ADDENDUM NO. TWO  
NCSB -FBMS

To the Plans and Specifications for:  
Nassau County School Board – Project No. 98110-031  
Fernandina Beach Middle School Kitchen / Dining Remodeling and Campus  
Renovations/Enhancements

Date: October 16, 2018

**KITCHEN HOOD PLAN VIEW**  
NOT TO SCALE

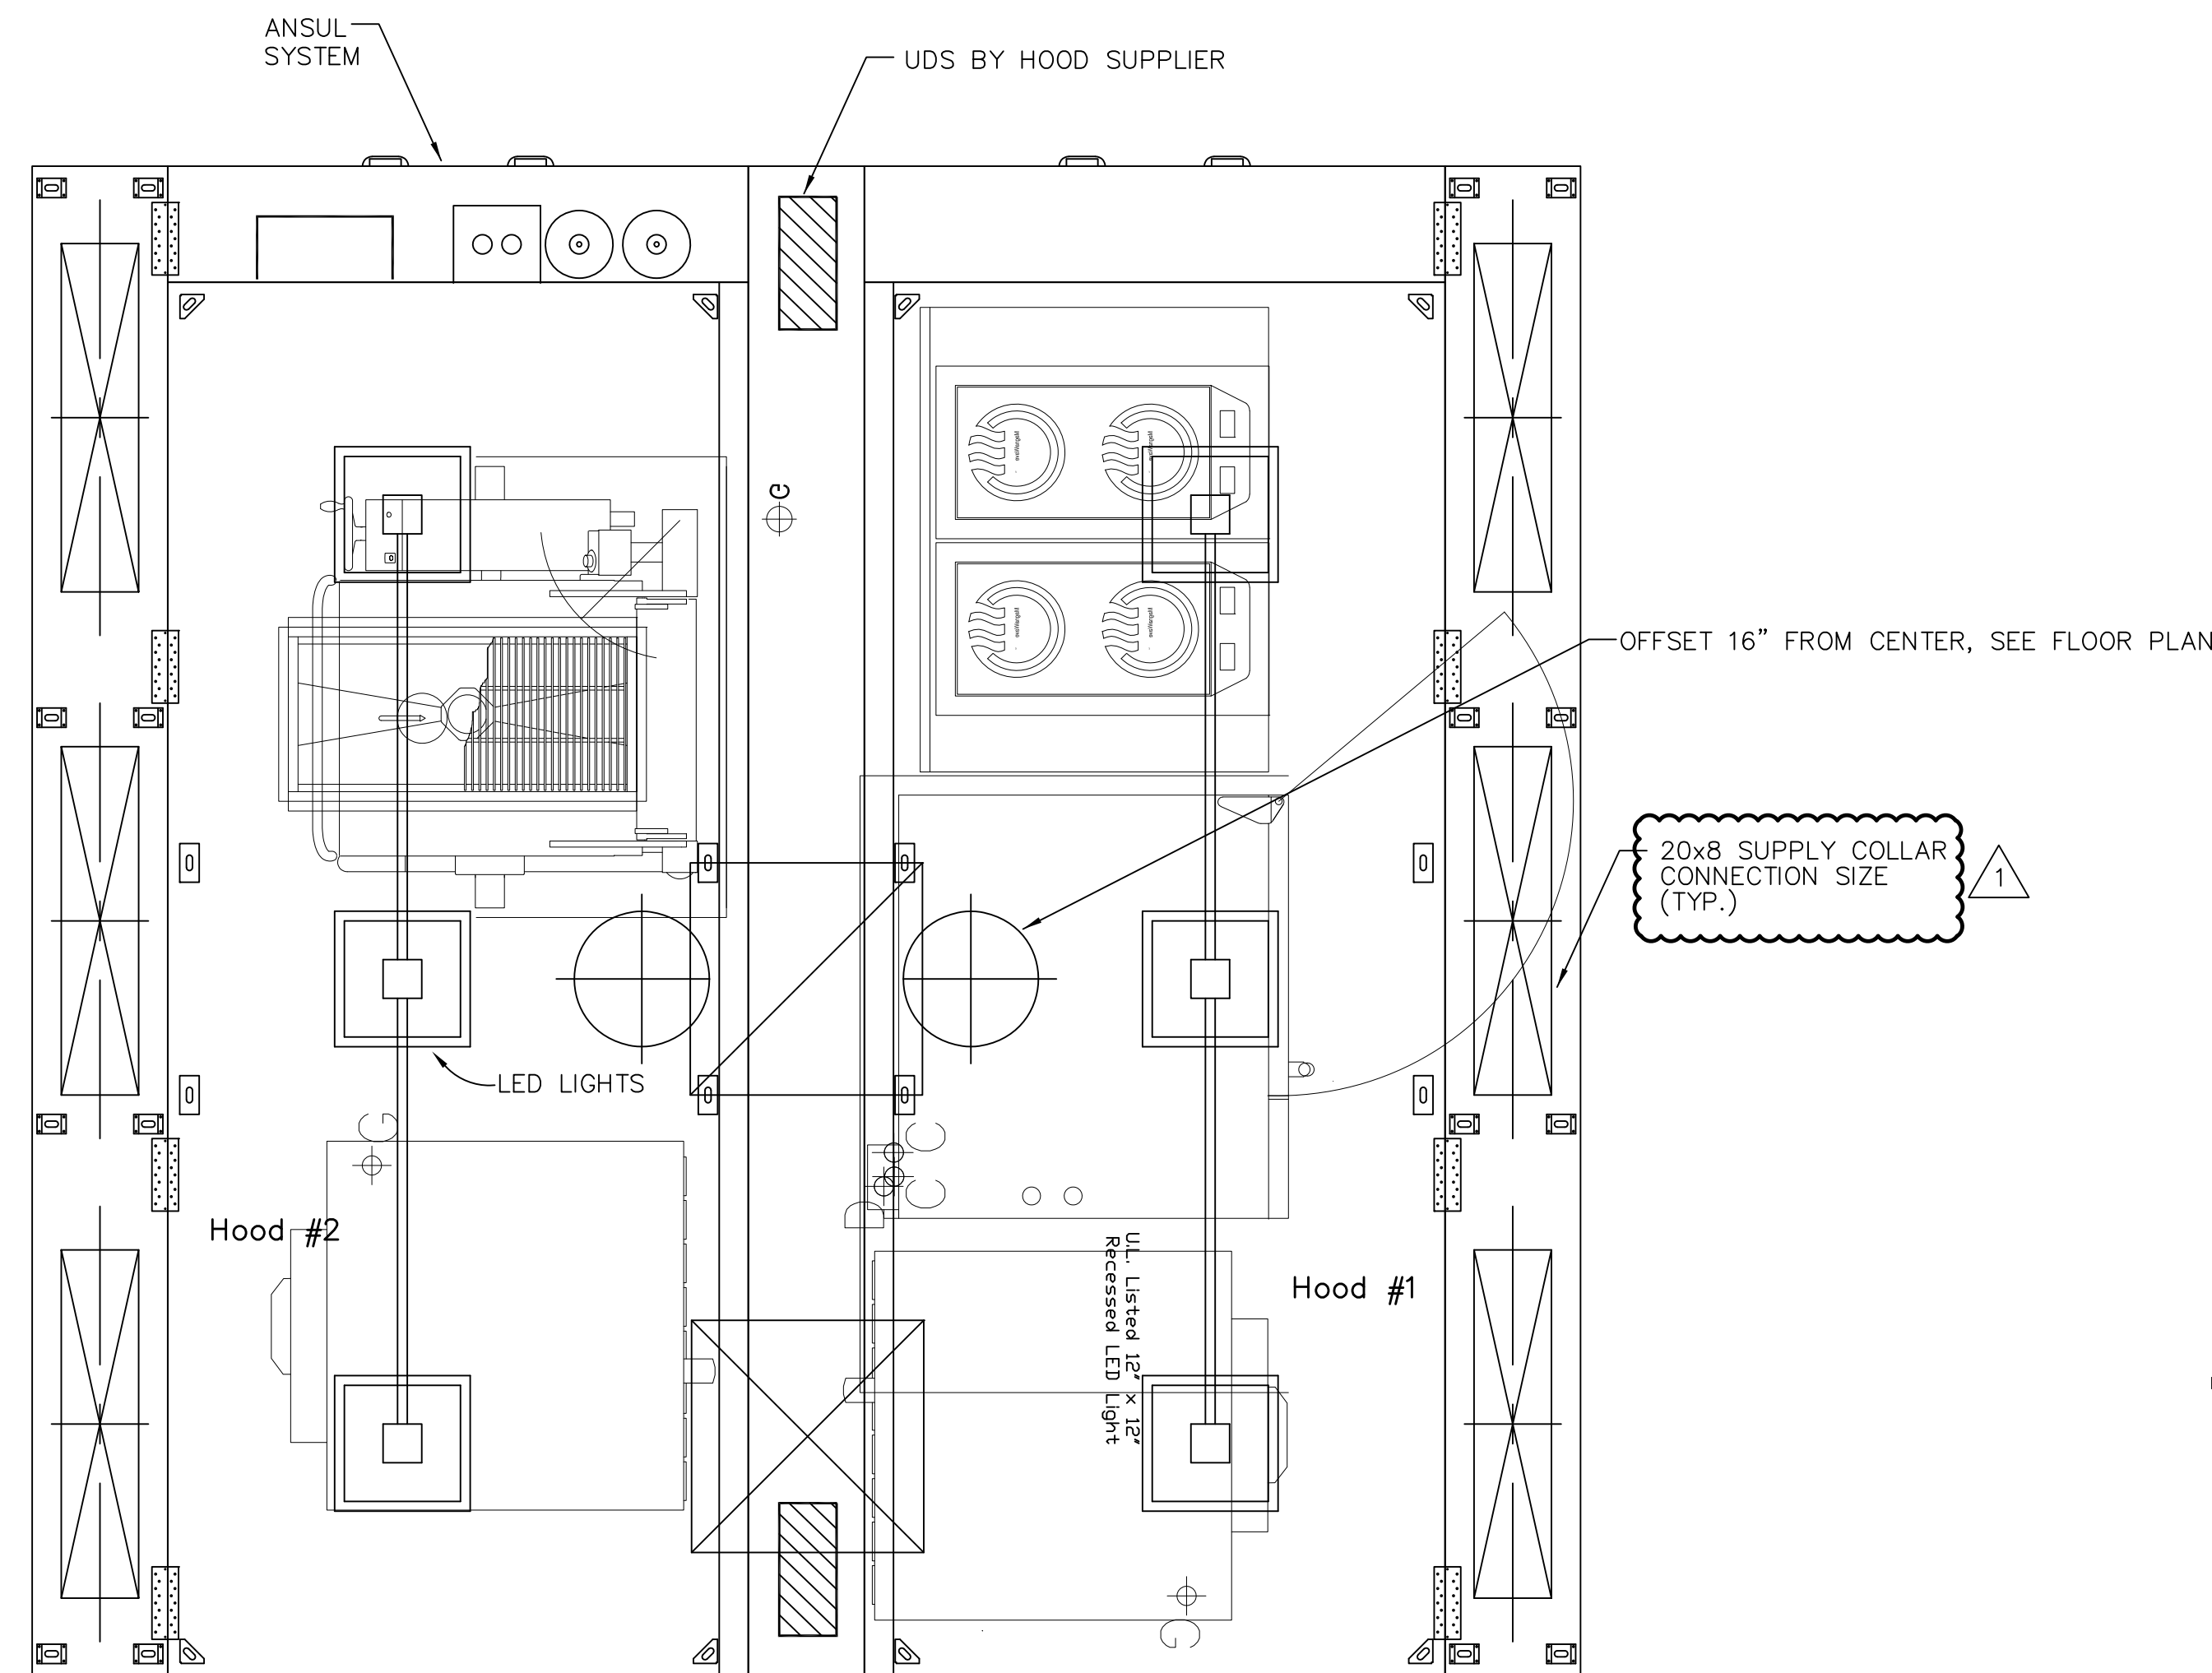
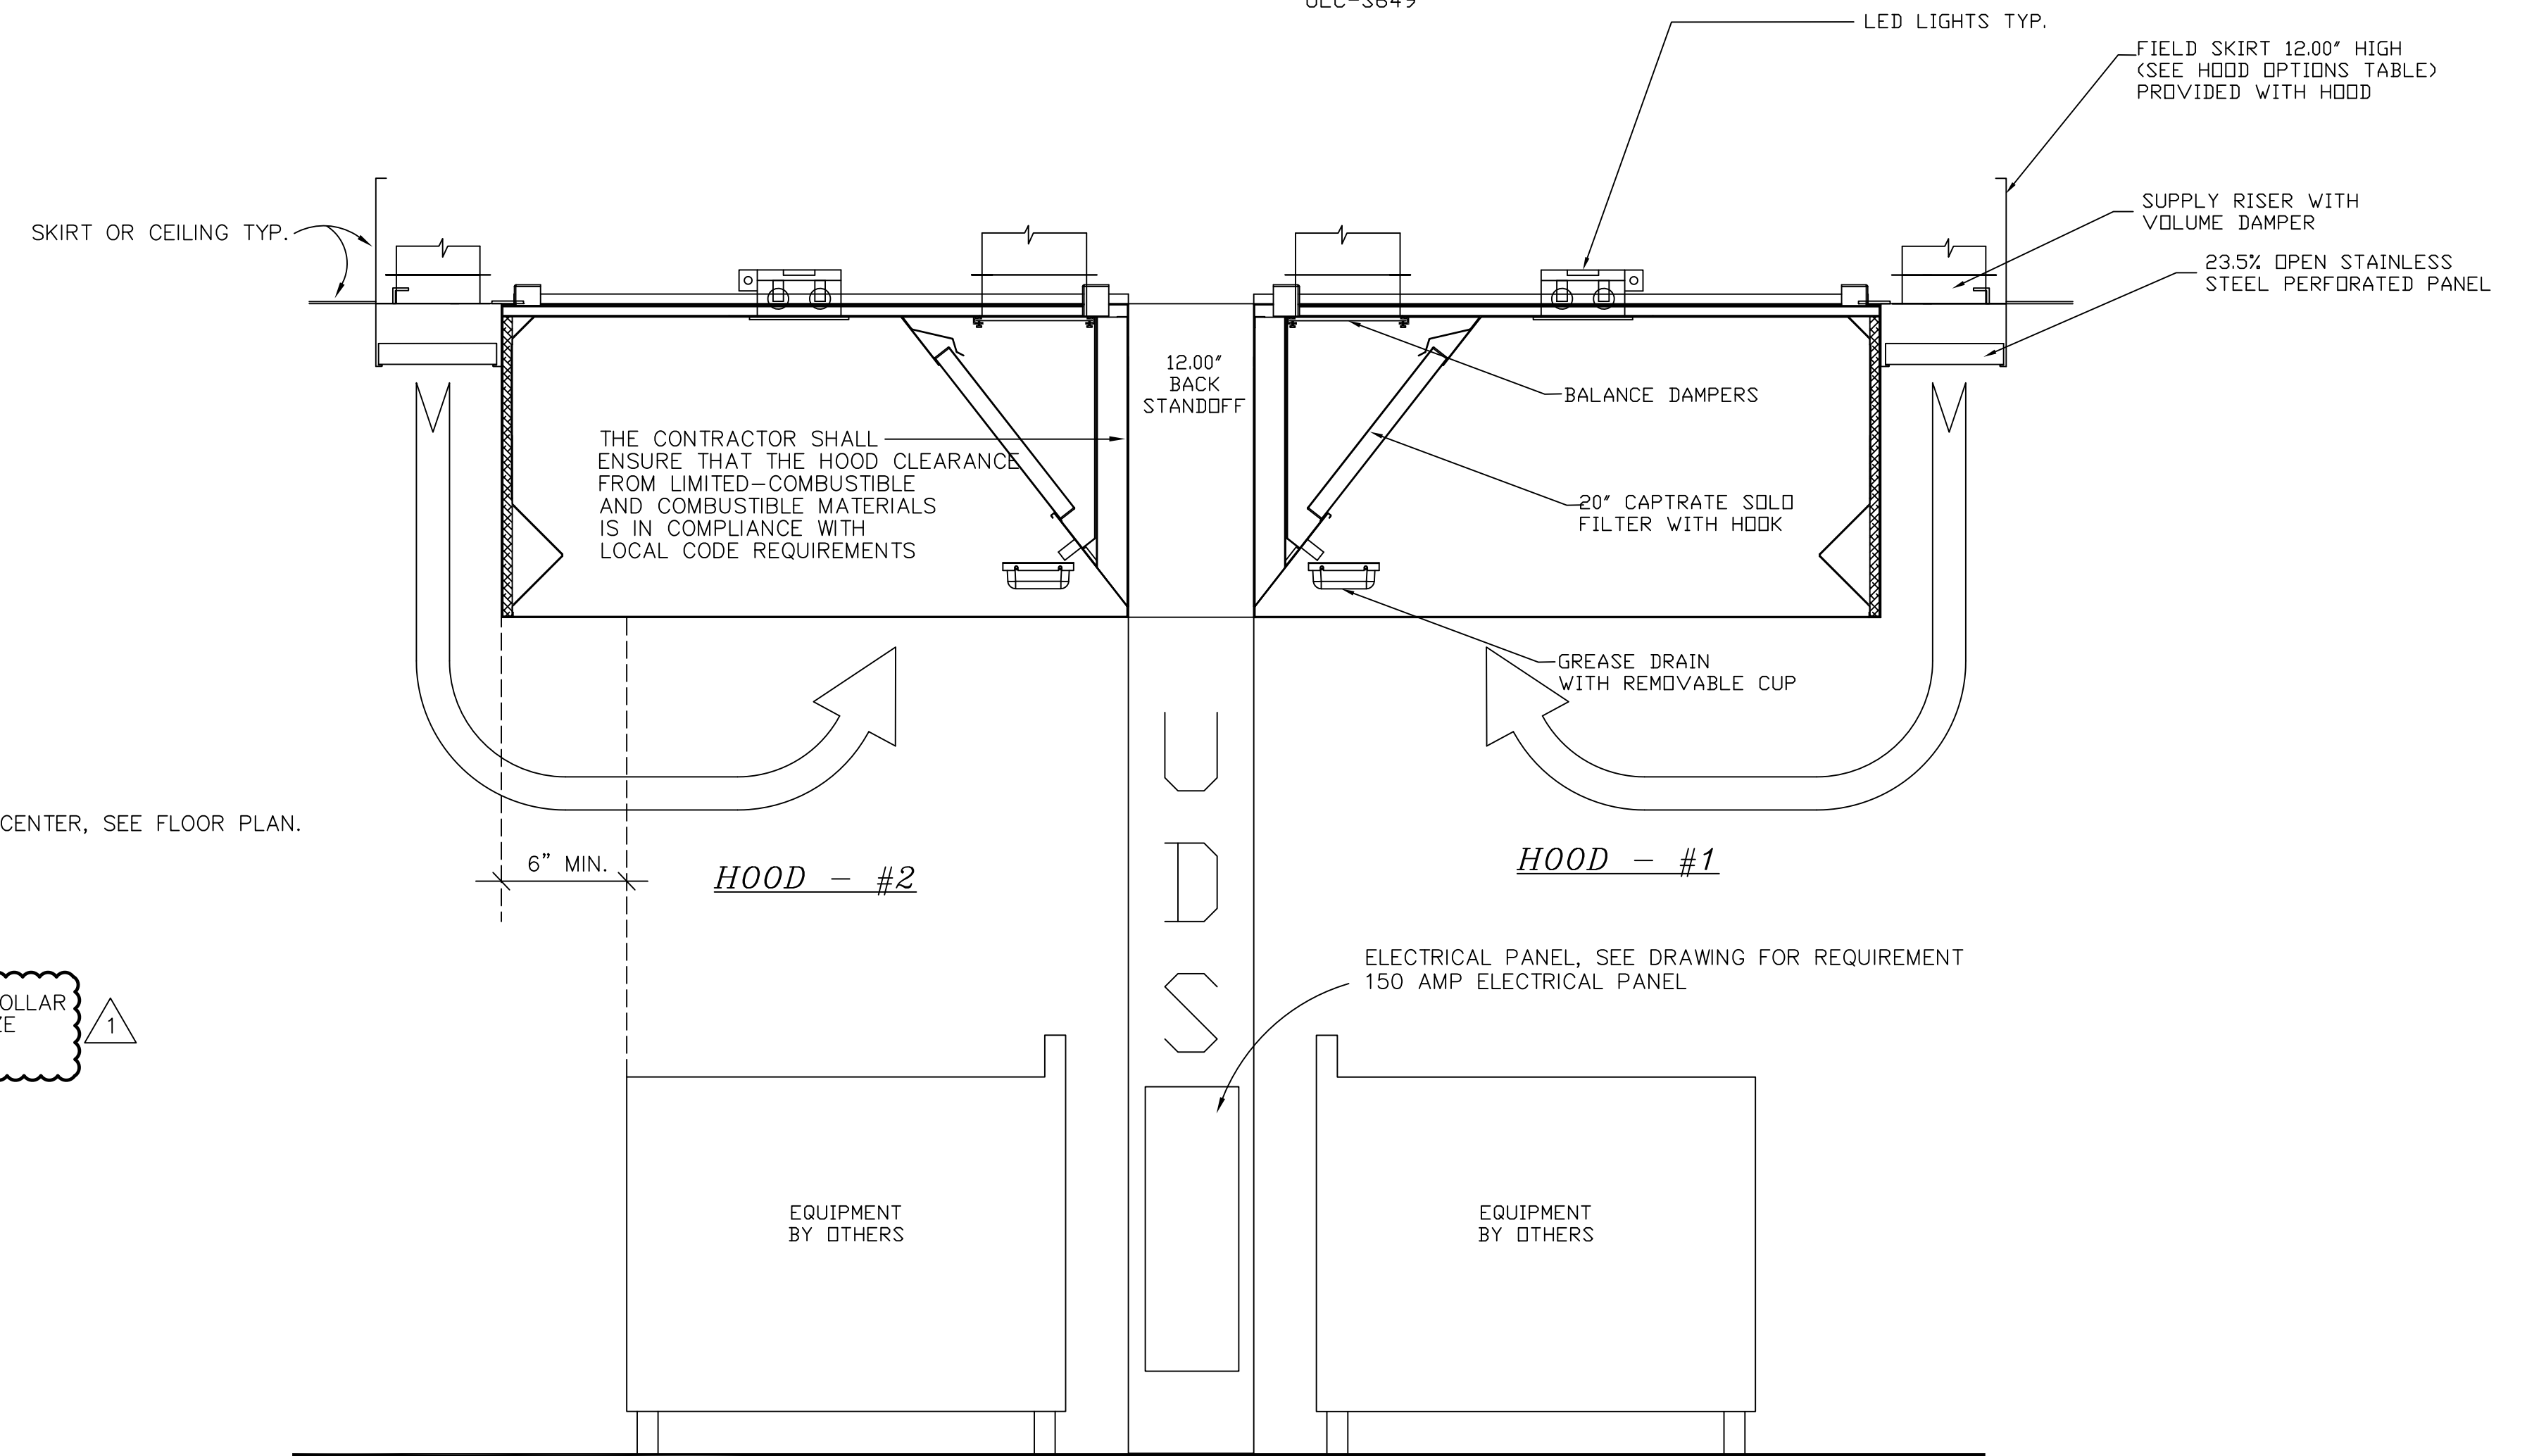
- a. Delete existing Drawing, M-14, dated 9/25/2018 and insert Drawing M-14, Dated 10/16/18.
- b. Delete TAG information in hood schedule and insert Hood #1 and #2 respectfully in four places.
- c. Kitchen Hood Plan View - Add note to size six supply duct connections at 20x8.
